## 106 Albert Street, London NW1 7NE - Addendum to Design & Access & Heritage Statement

July 2019

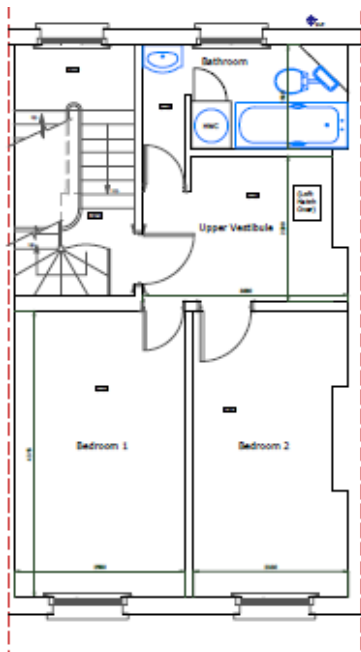
*The windows to both the front and rear have been replaced. To the front the windows are single glazed and replicate the historic glazing arrangement. To the rear, the windows are double glazed resulting in thicker glazing bars and unsatisfactory reflective qualities within the glass. As a result, the windows to the front are acceptable, but the council cannot support the double glazed windows to the rear.*

8. Rear windows – these will be timber sashes with single glazed laminate glass. ‘Histoglass’ is proposed with traditional timber glazing bars that will match those existing and accepted by the officers at the front elevation (refer to drawing no.203). Suggested type: ‘Mono’: 10mm thick, hand drawn glass (specification attached with this document).
9. The spotlights in the rear room at second floor level are to be removed and a pendant light to be fitted as agreed.

As existing prior to works

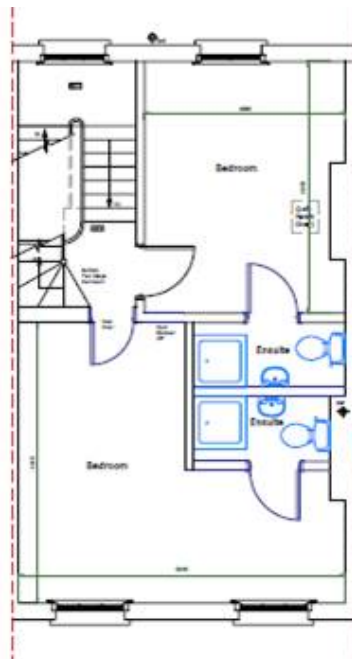
14. *At third floor the alterations to the plan form are not acceptable. The front room/rear room composition should be retained and any new staircase should not involve the removal of any historical internal walls. It would be helpful to have some evidence justifying a new staircase.*

15. The earlier configuration of the rooms on the 3<sup>rd</sup> floor include a vestibule in the rear room, which changed the original circulation even more fundamentally than the existing layout.

16. Prior to latest works, the front room was subdivided, thereby fully altering the planform on this level. The door into the front room (bedroom 1) had also been altered to allow for the later staircase to be inserted on the landing. This wall therefore has already undergone substantial alterations.

17. The staircase as consented in 2014, was deemed to be wholly impractical and would have resulted in a dangerous, impossibly steep staircase. It also would not have allowed for a landing at the top, where the consented utility is located. The current arrangement was implemented out of necessity as the consented one did not work.
